ADDENDUM NO.03

Bid No. 26-32FAC

**Jurupa Vista Elementary and Ruth O Harris Middle School Exterior Painting
Project No.26-55**

Site Key Plan

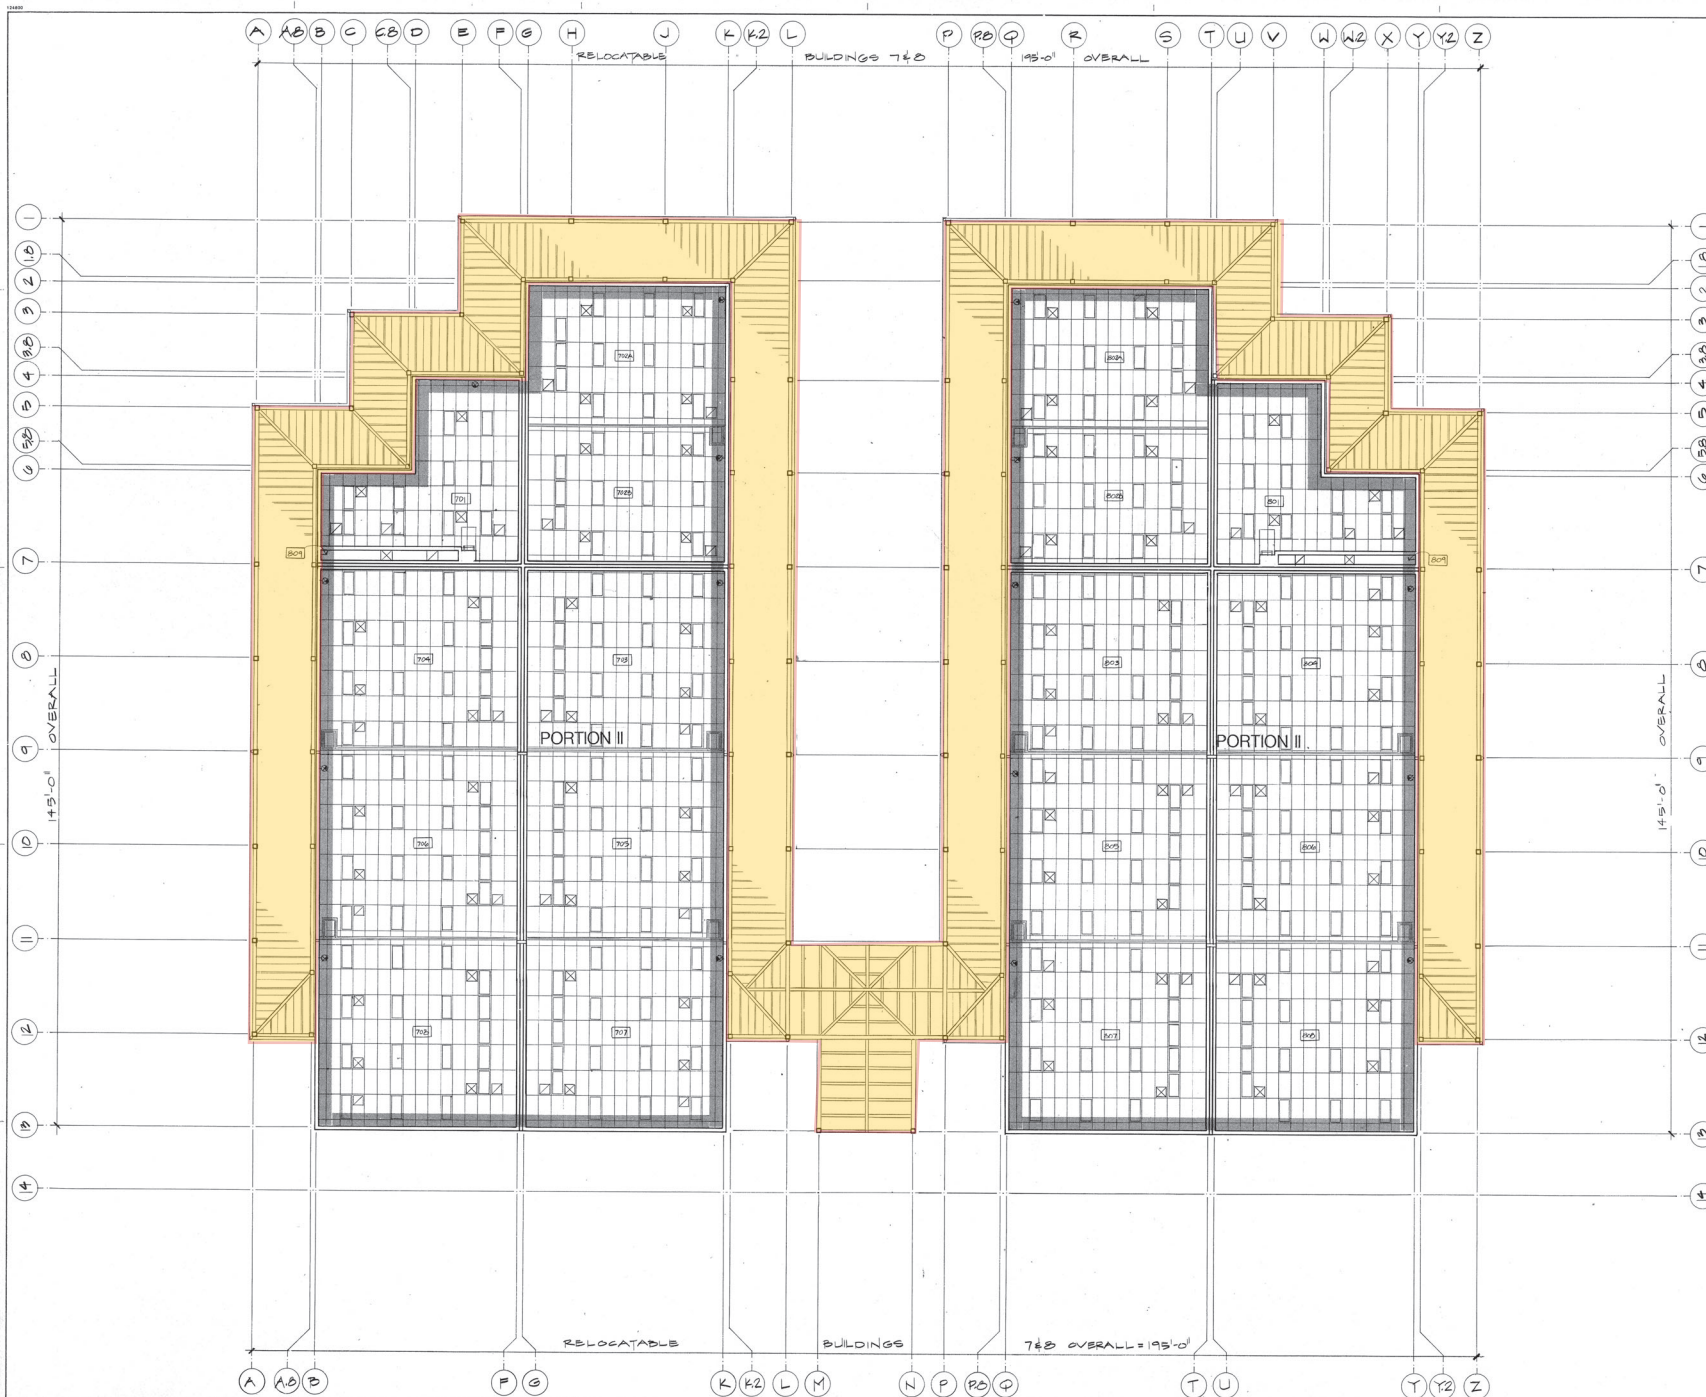
Reflected ceiling plan exhibit added to further clarify ceiling painting areas. All previous addenda responses and scope clarifications remain in effect.

Paint Exposed Metal and Cement Plaster Ceiling, Typical of All Sheets

The painting scope shall include only those roof and ceiling surfaces specifically identified in the renderings, exhibits, and subsequent addenda.

For the Ruth O. Harris Middle School project, visible metal roof surfaces depicted in the renderings as painted shall be painted P2 (DE6370 – Charcoal Smudge), unless otherwise noted.
